1 DETAILS OF THE DEVELOPMENT

Ref: 19/05194/PRE
Location: Citylink House, 4 Addiscombe Road, Croydon, CR0 5TT
Ward: Addiscombe West
Description: Demolition of the existing buildings. Erection of a part 27/part 13 storey building to provide approximately 494 shared-living units (sui-generis), 77 residential dwellings (C3), flexible (D1/B1) floorspace and retail/cafe (A1/A3) space
Drawing Nos: Submitted documents
Applicant: Fifth State
Agent: DP9
Case Officer: Louise Tucker

Image 7: flexible C3 plan

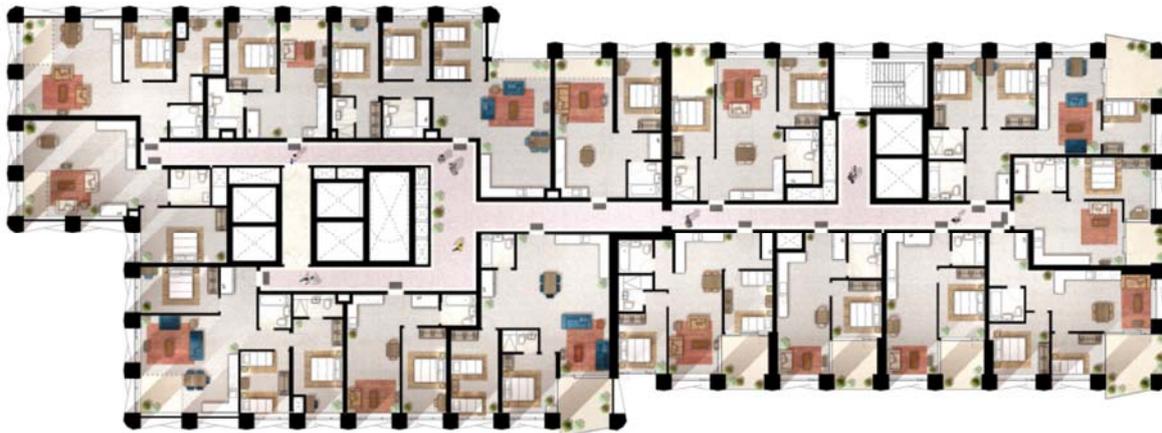
- 6.6 As with the College Tower scheme, officers have requested the applicant demonstrate that the co-living accommodation could easily be converted to C3 accommodation if there is no demand or need for this accommodation type in future. This would include consideration of location of services, doorways etc. to allow a flexible layout rather than the potential requirement for extensive conversion works.

Image 10: Developing bay studies of the façade

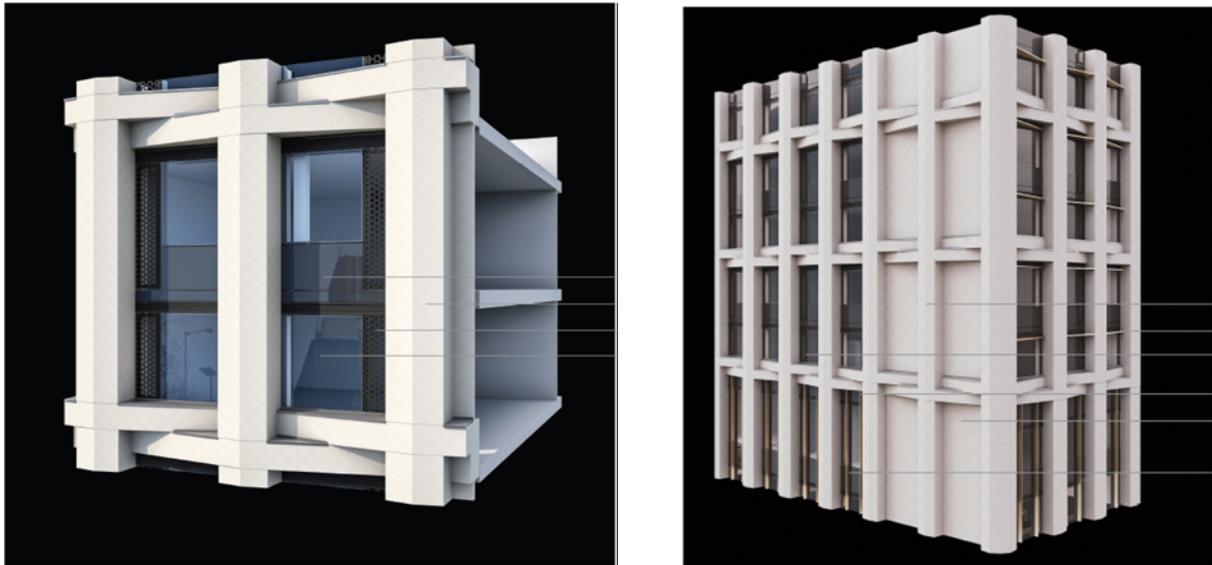
- 6.14 The design approach is focussed on incorporating the Croydon context and mid-century heritage which is supported in principle. Particular inspiration has been taken from the faceted form of the NLA tower to create subtle woven forms within the façade which articulate a uniform grid, reflective of the internal layout arrangement. Officers are working with the applicant to ensure the ‘weave’ is articulated robustly on the façade both in form and materiality. Whilst this is under development, officers consider that this is moving in a positive direction.

- 6.17 Whilst the complex intersecting and overlapping forms could be very successful, officers have questioned whether the chosen approach is the best approach in terms of dealing with water and weathering over the course of time. Whilst this could potentially be supported, officers need to be convinced that the aspirations shown in the façade studies actually can be achieved through elegant and robust detailing solutions. These technical challenges should be explored and resolved as part of the pre-application discussions and cannot be left to condition, as well as meaningful consideration of alternative options e.g. ceramic formwork.
